## **PLANNING DEPARTMENT STAFF REPORT AND FINDINGS:**

PUBLIC HEARING: THE RESERVE, PHASES 3–6 – Preliminary Subdivision Approval (File: SUB 22-16)

#### ADA impact at new proposed 10<sup>th</sup> Ave connection

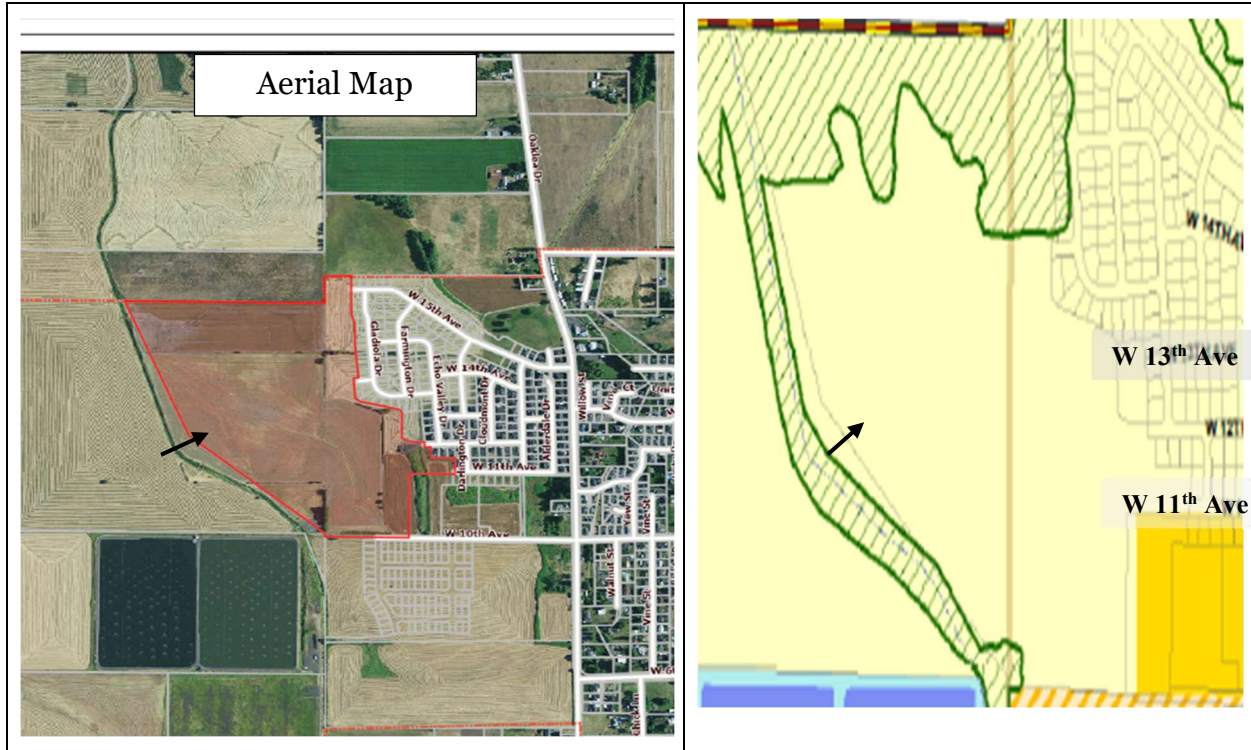
- Lane County scope of study includes a review of completed frontage and roadway improvements with applicable Lane Code requirements. Please provide an analysis of 10<sup>th</sup> Ave intersection improvement status and identify deficiencies relative to current ADAAG, PROWAG and Lane County Code specific requirements.
- An analysis of required transitions between improved and unimproved sections and identification of a responsible party is required.
